Re: Union Pacific Railroad Company's July 5, 2001 responses to TNRCC's November 6, 2000 comments on the Affected Property Assessment Report, Houston Wood Preserving Works, dated July 10, 2000
Industrial Solid Waste Registration No. 31547
EPA ID No. TXD000820266

Subject: Transmittal, Responses to TNRCC's November 6, 2000 comments
on an Affected Property Assessment Report; Houston Wood Preserving Works
Site; TNRCC Solid Waste Registration No. 31547; EPA ID No. TX000820266

**On-Site Affected Property Assessment Report
Former Houston Wood Preserving Works
Union Pacific Railroad
Houston, Texas**

FIGURE 1
SITE MAP
HOUSTON WOOD PRESERVING WORKS
Houston, Harris County, Texas

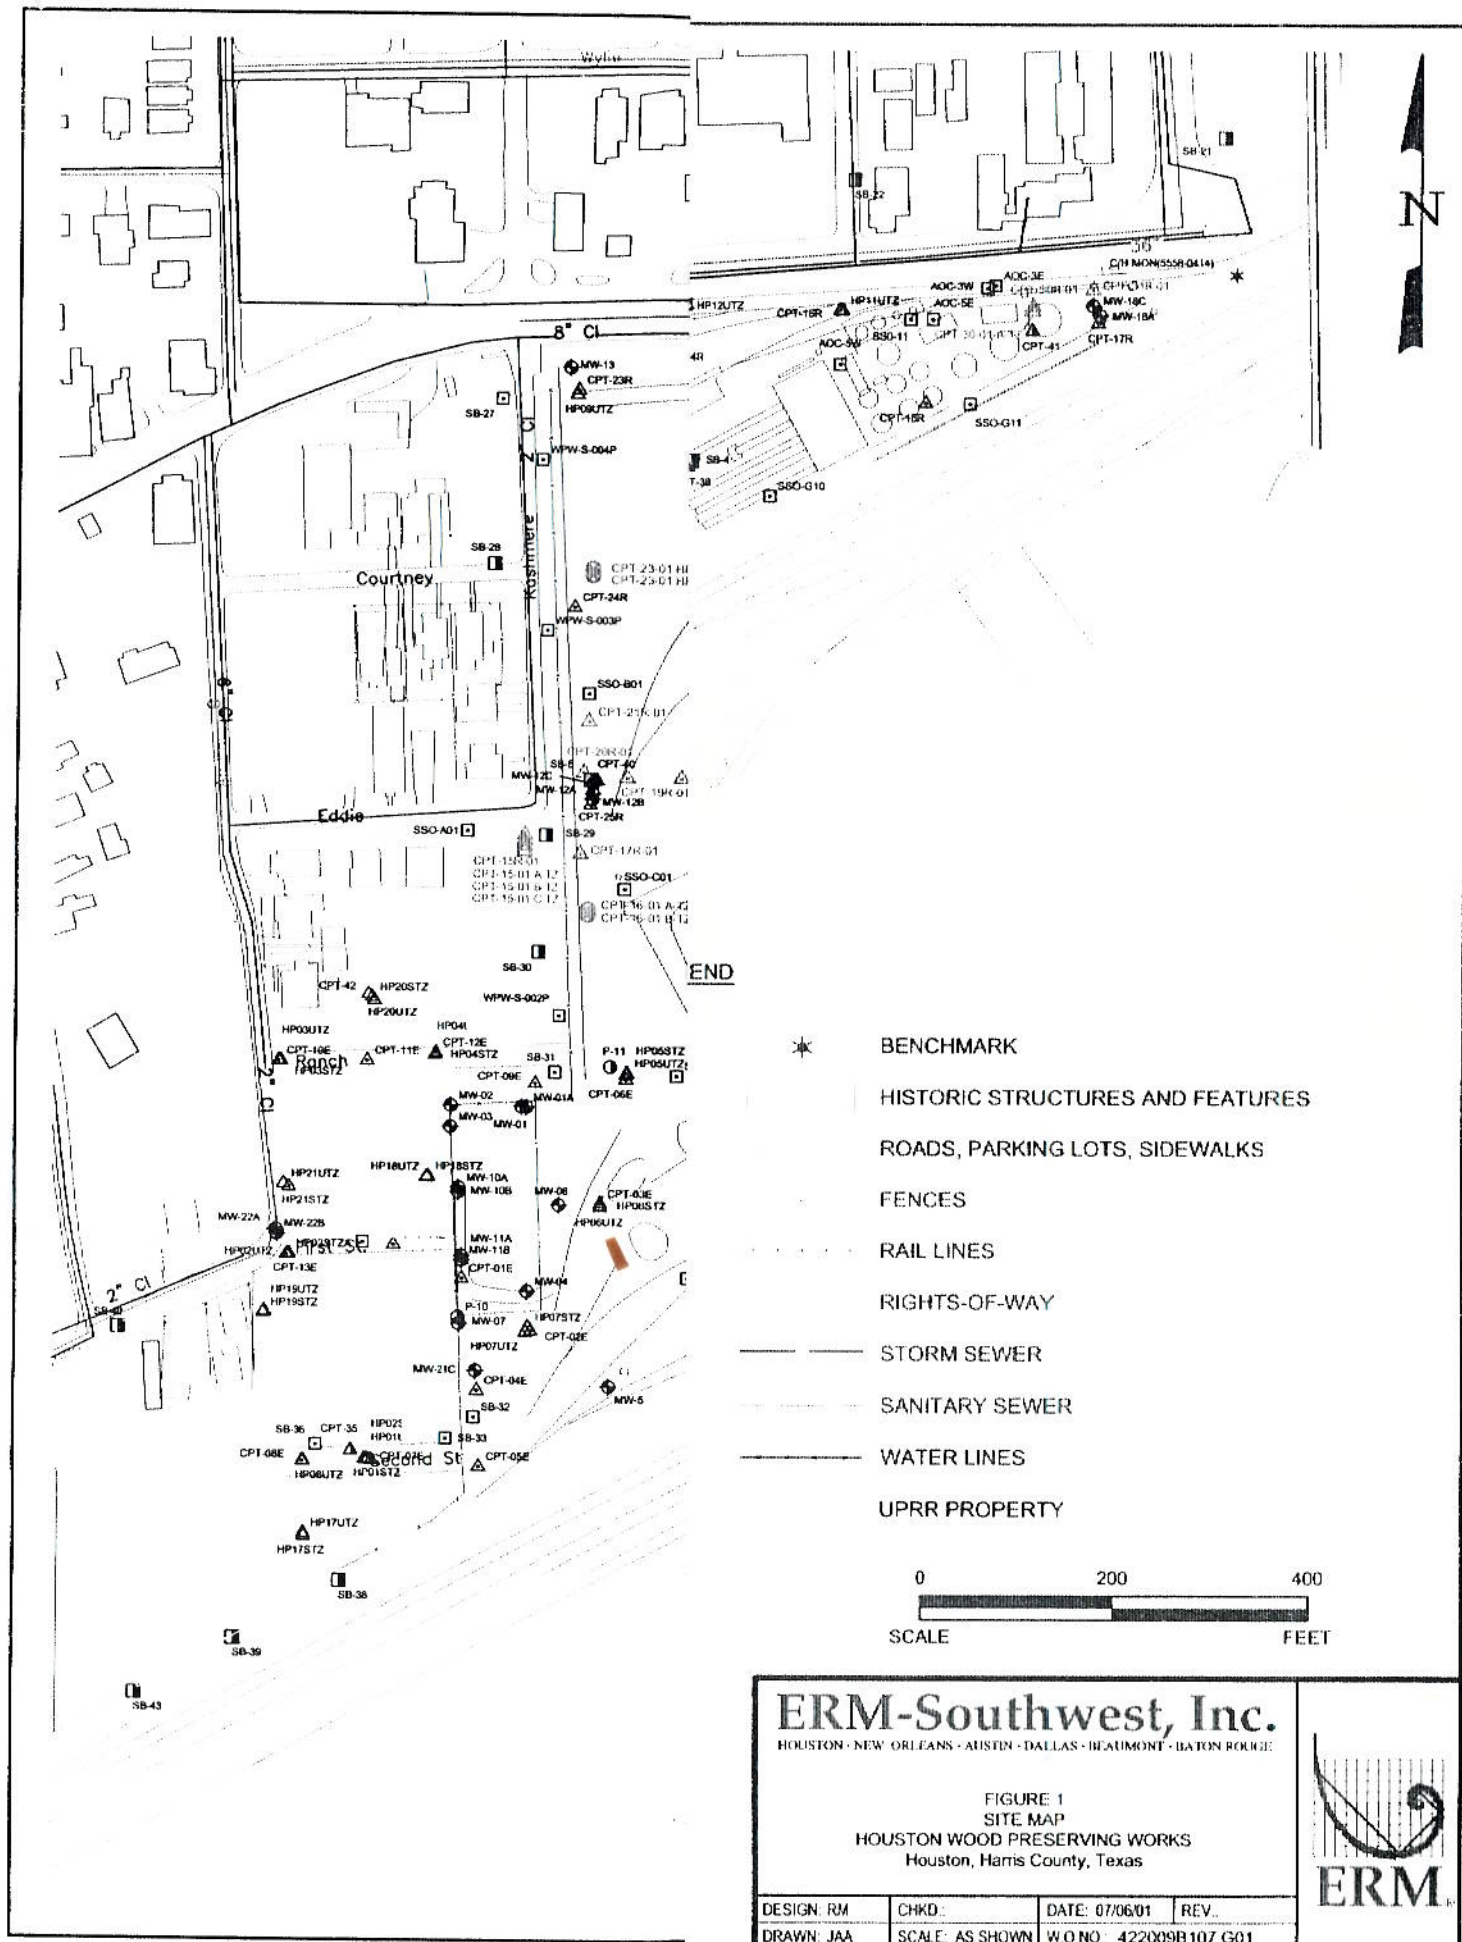
Section 7.0 - Revise the text and figures to define the source and extent of the Dense Non-Aqueous Phase Liquid (DNAPL) detections in monitoring wells MW-17 and MW-18C.

Figure 7-1 - the figure indicates that additional on-site monitoring wells are needed to characterize and define the extent of the PCLE Zone in the A-Transmissive Zone Groundwater (A-TZ) associated with monitoring well MW-12A and the PCLE Zone located hydraulically up gradient of monitoring wells MW-15A and MW-20A.

Figure 7-2 - The figure indicates that additional on-site monitoring wells are needed to characterize and define the extent of the PCLE Zone in the B-TZ associated with monitoring well MW-12B.

Section 9.0, pp. 44-45 - Install and sample two new monitoring wells in the A-TZ. Locate one well immediately downgradient of soil borings SB-3, SB-7, and SB-8, and locate the other well immediately downgradient of soil boring SB-4.

Section 9.0, pp. 44-45 - Additional assessment is necessary to determine the source and define the extent of the DNAPL present in monitoring well MW-12B.

To assess the extent of DNAPL in the vicinity of MW-17, three CPT-ROST borings, CPT-26R-01, CPT-27R-01, and CPT-28R-01, were completed to the south, north, and east, respectively, in March 2001 (Figure 1). The ROST data from CPT-26R-01, CPT-27R-01, and CPT-28R-01 indicate that the measured fluorescence was at or approaching background levels at a depth of 65 feet below ground surface.

Two CPT-ROST borings were completed in the vicinity of MW-18C during March 2001. The ROST data from CPT-30R-01 and CPT-31R-01 (Figure 1) indicate that the measured fluorescence was at background levels at a depth of 65 feet below ground surface.

Ground water grab samples were collected from CPT-16-01 HP A-TZ, CPT-18-01 HP A-TZ, CPT-22-01 HP A-TZ, and CPT-23-01 HP A-TZ (see Figure 1). The grab ground water results indicate that only a few COCS exceed the critical PCLs. Specifically, benzene and naphthalene at CPT-18-01 HP A-TZ and benzo(a)pyrene at CPT-22-01 HP A-TZ are reported at concentrations that exceed the critical PCLs. Based on these data and the data available from monitor wells MW-13 and MW-14 and the grab ground water sample from HP05UTZ the extent of the A-TZ ground water PCLE zone can be inferred within reason.

Additional ground water grab samples were also collected from the A-TZ at CPT-24-01 HP A-TZ and CPT-25-01 HP A-TZ (see Figure 1). These locations are hydraulically upgradient of MW-15A and MW-20A and were intended assist in the delineation of the PCLE Zone to the southwest. The analytical results for the ground water sample collected from CPT-24-01 HP A-TZ indicate critical PCL exceedances for only dibenzofuran and naphthalene. The ground water sample collected from CPT-25-01 HP A-TZ had no exceedances of the critical PCLs for the COCs analyzed. From these data and the laboratory analytical data from MW-14, the A-TZ ground water PCLE zone has been defined to west (hydraulically upgradient) of MW-15A and MW-20A.

To assist in the delineation of the PCLE zone in the B-TZ around monitor well MW-12B, additional data was collected in March 2001. Ground water samples were collected from CPT borings CPT-16-01 HP B-TZ, CPT-18-01 HP B-TZ, CPT-22-01 HP B-TZ, and CPT-23-01 HP B-TZ (see Figure 1). Several constituent concentrations exceed critical PCLs for the ground water grab samples collected within the B-TZ at locations CPT-16-01 HP B-TZ (dibenzofuran, naphthalene, benzo(a)pyrene, and benzo(a)anthracene) and CPT-18-01 HP B-TZ (benzo(a)pyrene, benzo(a)anthracene, chrysene, dibenzofuran, 2-methylnaphthalene, and naphthalene). However, the results from ground water samples collected from CPT-22-01 HP B-TZ and CPT-23-01 HP B-TZ indicated no critical PCL exceedances. Therefore, the extent of the PCLE Zone was defined by the results from CPT-22-01 and CPT-23-01 and piezometer P-11.

One ground water grab sample was collected from the A-TZ was collected down gradient of soil borings SB-3, SB-7, and SB-8 at CPT-29-01 HP A-TZ (see Figure 1). The analytical

A ground water grab sample was also collected down gradient of SB-4 at CPT-30-01 A-TZ (Figure 1). The results from this sample indicate critical PCL exceedances for only benzene, dibenzofuran, naphthalene, and 2,4-dimethylphenol.

Further investigation activities were conducted to delineate the extent of the DNAPL in MW-12B. CPT-ROST data from CPT-17R-01, CPT-19R-01, CPT-20R-01, CPT-21R-01, and CPT-32R-01 was collected north, east and south of MW-12B to qualitatively assess the presence of NAPL in these locations (see Figure 1).
